# **STAFF REPORT**

**March 8, 2017**

**Case #05-17: SITE PLAN REVIEW**  
**Case #06-17: SPECIAL PERMIT FOR  
PARKING REDUCTION**  
72 North Water Street  
Map 53, Lots 68, 291, 295

##### **Site Layout – (SL) Sheet 1 of 7**

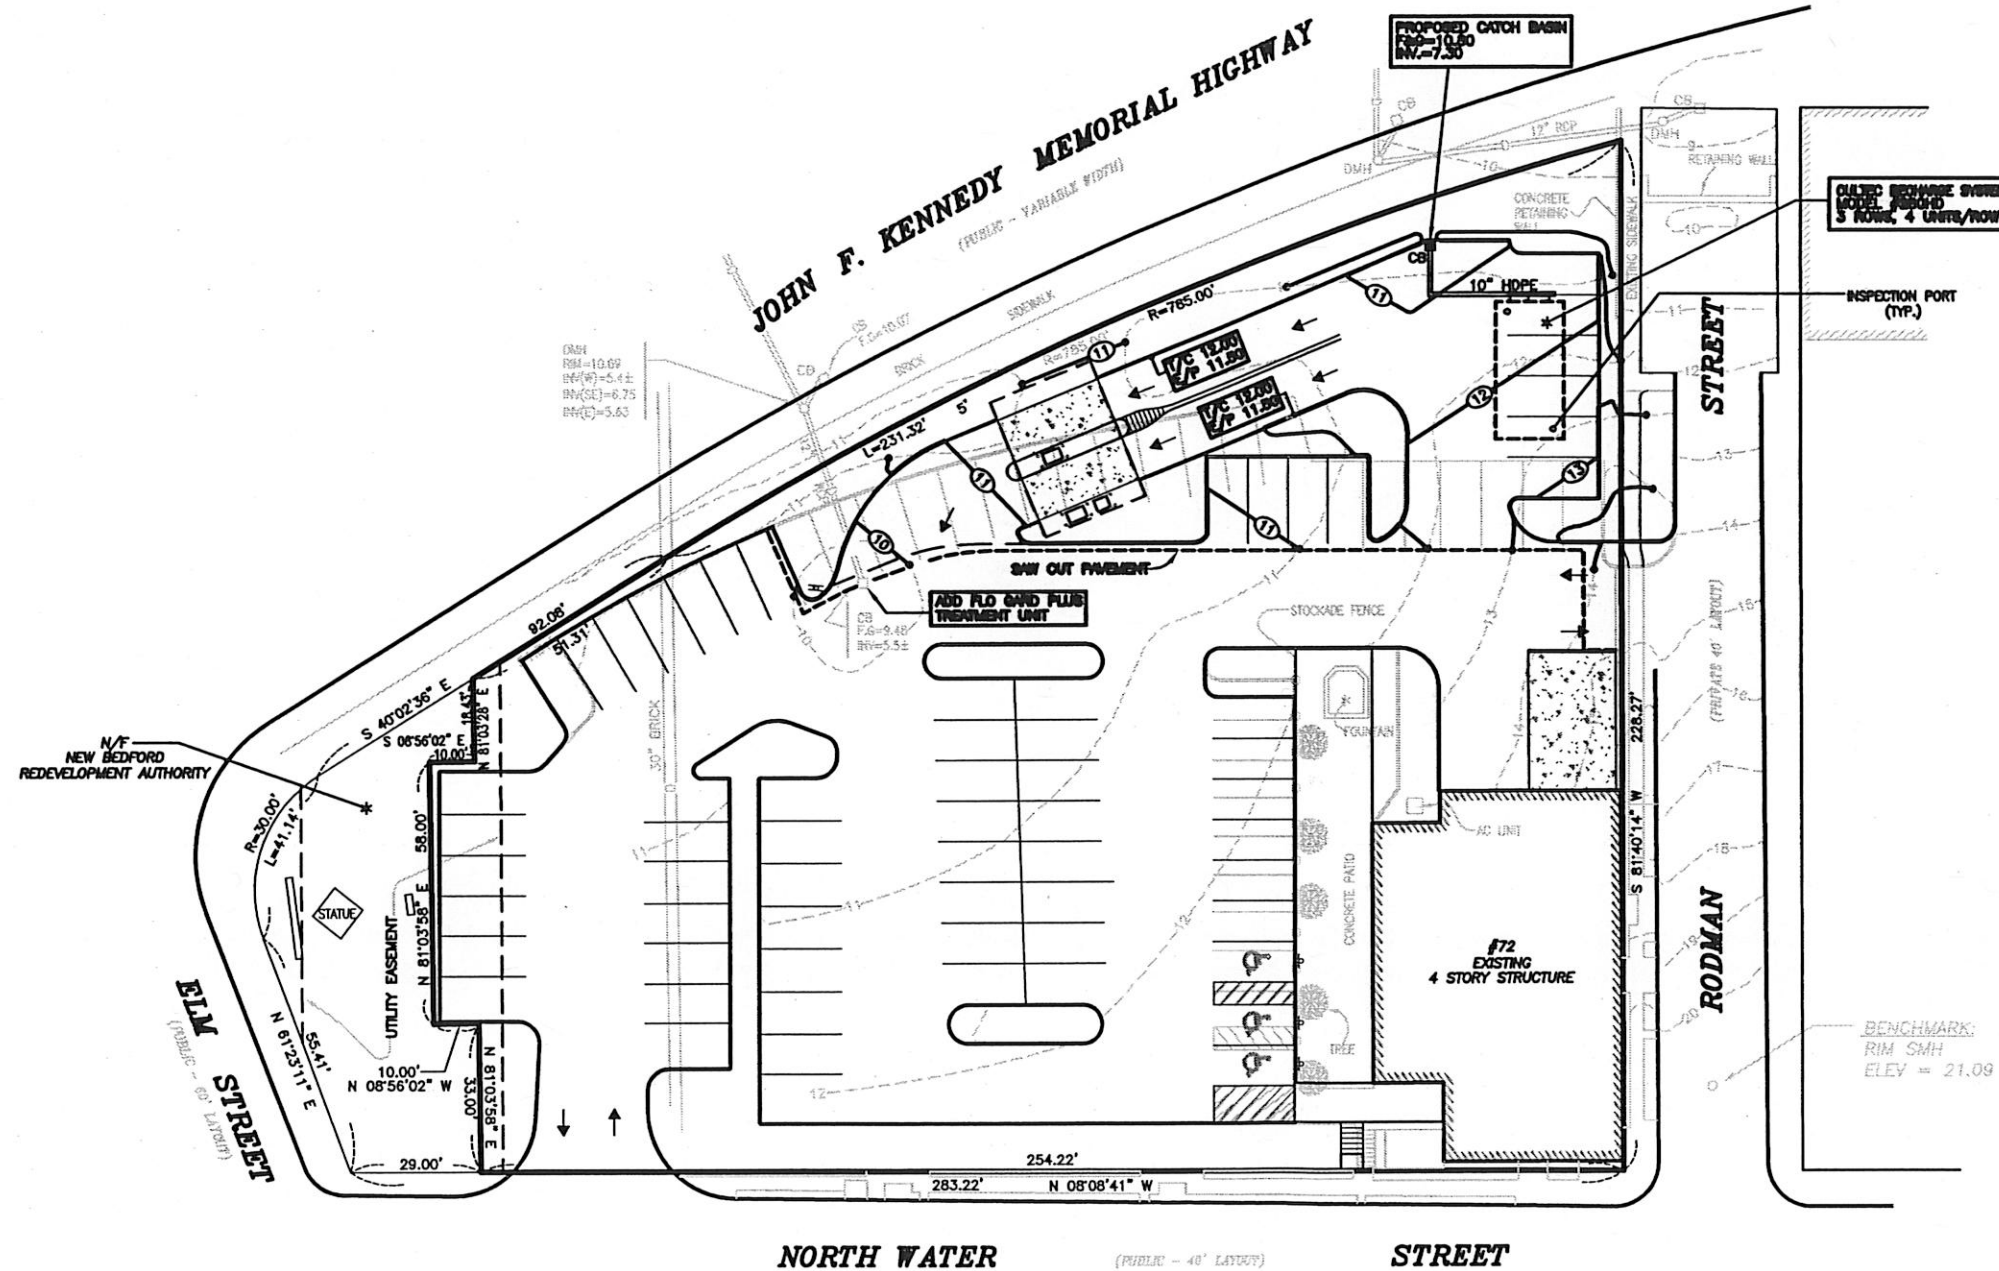
- Add to Notes: *The applicant shall present any proposed modification from the approved plans for consideration to the City Planner for determination as to whether the modified plan must return before this Board for further review.*
